Traffic Calming (Speed Humps) - Hillsdale Avenue East

Date: January 2, 2017
To: Toronto and East York Community Council
From: Acting Director, Transportation Services, Toronto and East York District
Wards: Ward 22, St. Paul's

Re: Traffic Calming Measures – on Hillsdale Avenue East, between Cleveland Street and Bayview Avenue – Evaluation for the installation of traffic calming measures (i.e. Speed Humps).

**HILLSDALE AVE E
FROM CLEVELAND ST TO BAYVIEW AVE
PROPOSED SPEED HUMP LOCATIONS PLAN**

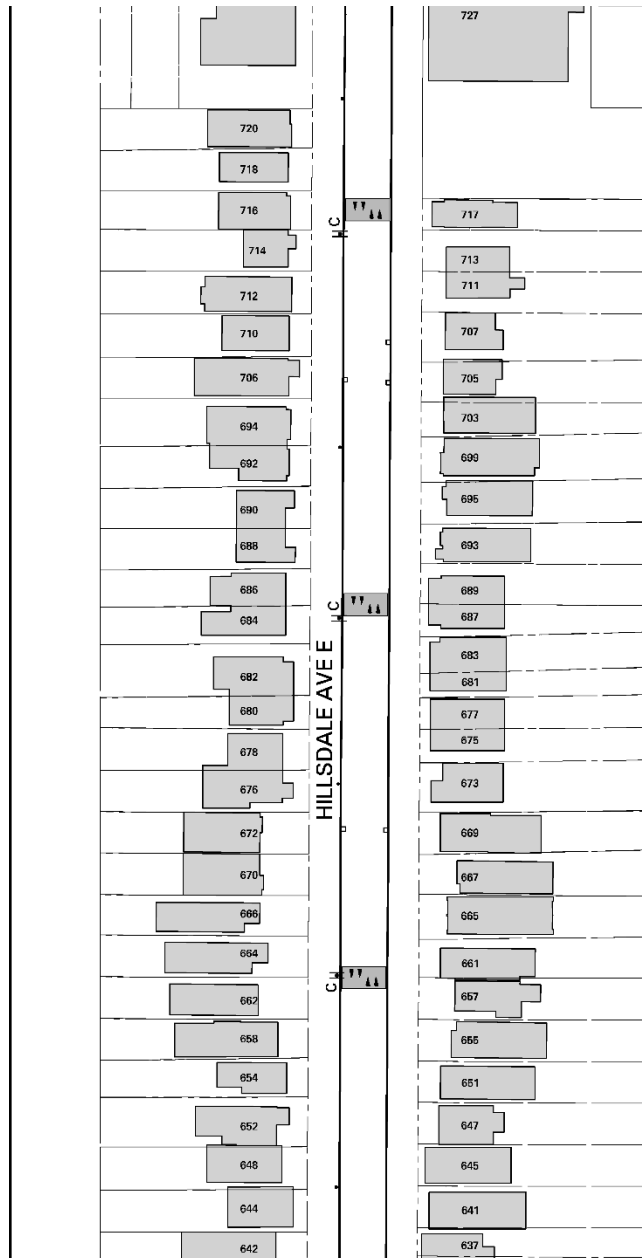
I have received and reviewed the proposal for installation of speed humps on Hillsdale Avenue East, between Cleveland Street and Bayview Avenue. I have the following comments:

As documented in the Traffic Calming Policy, Toronto Paramedic Services has concerns regarding the usage of traffic calming measures, specifically vertical obstacle measures such as speed humps. These have a negative impact on emergency call response times, travel times to hospital and on patient comfort during transport. This delay is cumulative with each obstacle and can directly impact patient outcome.

In addition to concern for patient outcome and safety it is noted that this proposal does not meet the Warrant Criteria as set out in the Policy. Therefore, Toronto Paramedic Services is opposed to the installation of traffic calming devices on Hillsdale Avenue East, between Cleveland Street and Bayview Avenue. It is important that the applicant fully understands the potential for delay in emergency response and that alternatives to vertical measures be considered and evaluated.

I am in receipt of the proposal for installation of traffic calming measures (speed humps) and provide the following comments.

Fire Services does not support the proposed speed hump installation as they may slow our responding vehicles and affect delivery of service in the quickest possible manner. Increased time can have impact the effectiveness of the services provided during an emergency. The vertical restrictions imposed by a speed hump have a much greater impact on larger fire vehicles than smaller passenger vehicles. Response time increase with every obstacle a fire vehicle encounters on route to any emergency incident. Although the increase at each hump may only be seconds, the cumulative effect can be a significant amount of time.

Fire Services recommends that non-physical measures (lower speed limits or prohibited turns) be implemented and evaluated before physical forms are considered. Desired results may be obtainable without imposing a physical obstruction to emergency vehicles.
